Review of Preston New Road Environmental Statement

Technical report

Health Impact Assessment Support, shale gas exploration

Lancashire County Council

Figure 3-1: South Blackpool development hub potential expansion

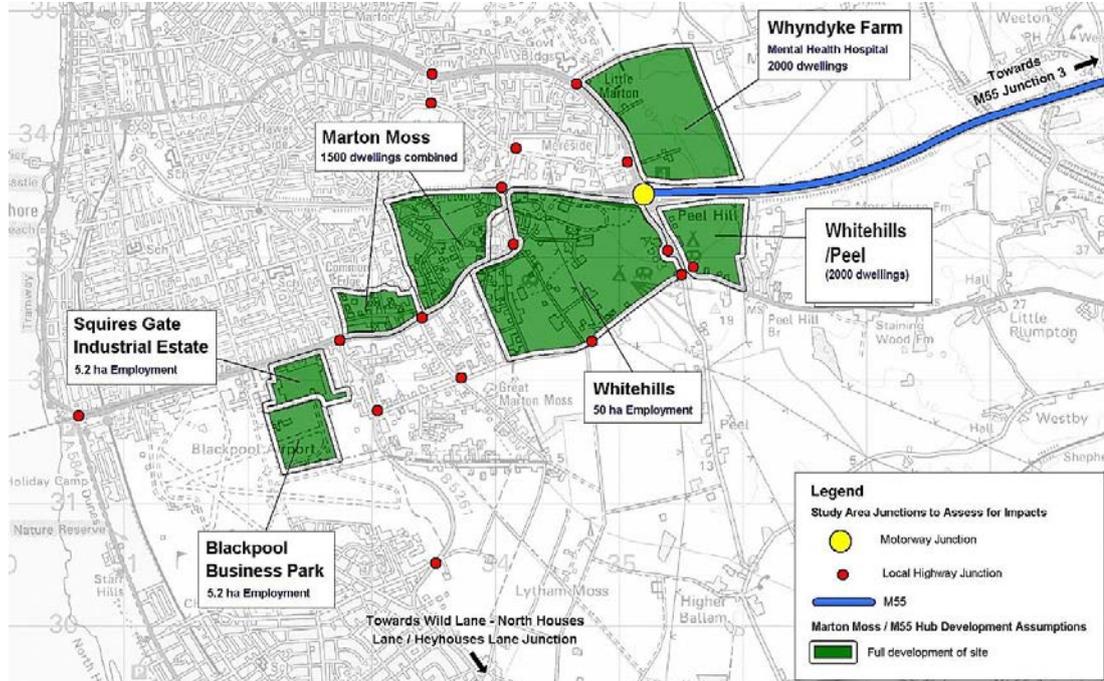
- 3.3.9 A potential gap in the cumulative impacts section of the ES is the proposal for the 'development hub' of as many as 5,500 new homes near the A55 interchange, to the east of Blackpool. The expansion could also include around 60 ha or employment land and a

Mental Health Hospital at Whyndyke Farm (19). The Blackpool emerging Core Strategy (20) Policy CS25 describes South Blackpool housing growth, including lands around Junction 4 of the M55. Policy CS24 also supports employment growth for this area.

Figure 3-2: Noise from hydraulic fracturing pumping operations calculated at ground floor level (to reflect daytime impacts)

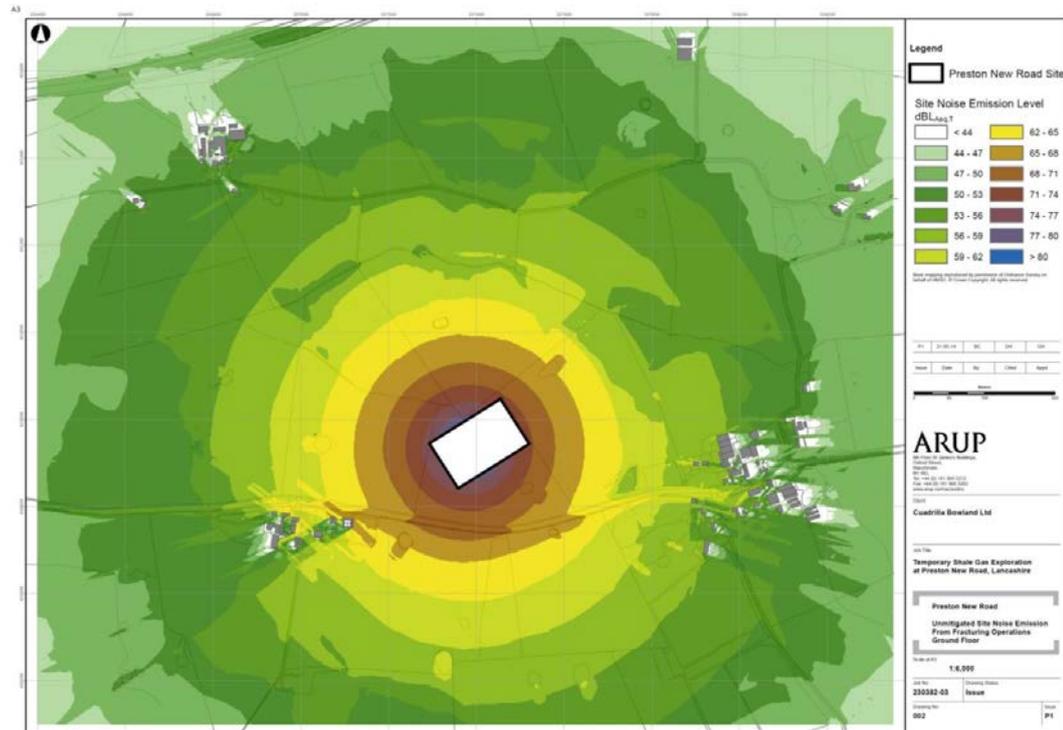
after 13:00 and Sunday. Hydraulic fracturing equipment noise is a potential impact the HIA may wish to consider in more detail.

- 3.5.20 Figure 3-2 is reproduced from ES Appendix P to show the potentially most significant noise impact of the project, hydraulic fracturing.
